STAFF REPORT: 10/08/2025 REGULAR MEETING

APPLICATION NUMBER: HDC2025-00575

ADDRESS: 2733 SECOND AVENUE (AKA CASS PARK)

SCOPE: ALTER & REHABILITATE PARK, REVISE INTERNAL PATH LAYOUT

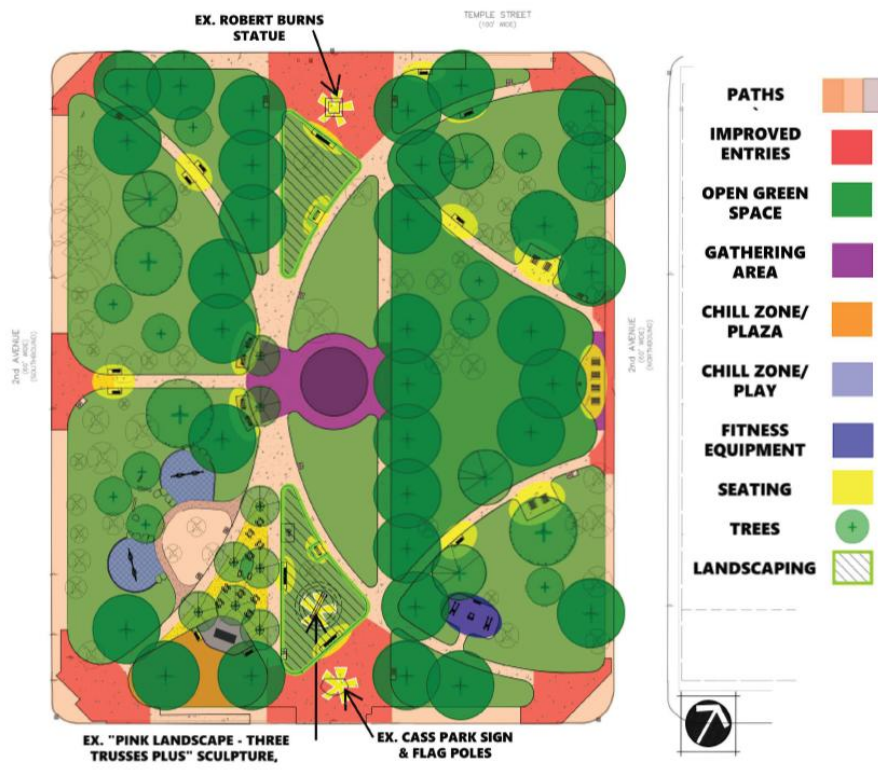
- Staff acknowledges the addition of north-south paths at a dimensional spacing that is in keeping with the width of Second Avenue’s north-south axis. The revision of tree placement at those paths will further strengthen that vista from within and outside of the park.

- The inclusion of a circular feature creates an identifiable central element akin to the original placement of the 19th century fountain. Currently identified to be a grassy gathering area, it creates a prominent space which also allows for the future inclusion of a fountain or other physical/visual “destination” component.

- However, taking into account the district’s Elements of Design and the park’s level of integrity, it is staff’s opinion that the proposed overall layout is still not a compatible park plan as it will destroy the symmetrical design of eight entries converging on the center of the park from each corner and center of the four sides, which is significant and distinctive character-defining feature of the park, and the one element that has essentially remained unchanged from the original 1860 park design.

- The new design will remove the historic circulation patterns, including the central axis and placement of the historic paths and their relationship to the central open space, thus altering the distinctive features and spaces that characterize the property.
- The applicant has not demonstrated that a park design that is compatible with the existing circulation pattern cannot meet the interests and potential uses listed within the public engagement document.
- Specifications for the proposed sign were not included in this application, including size, material, post(s) and placement (it isn’t identified on the site plan).

Recommendation 1 of 1, Denial

Staff recommends that the proposed work will be inappropriate according to the Secretary of the Interior's Standards for Rehabilitation and the Cass Park Local Historic District's Elements of Design, specifically:
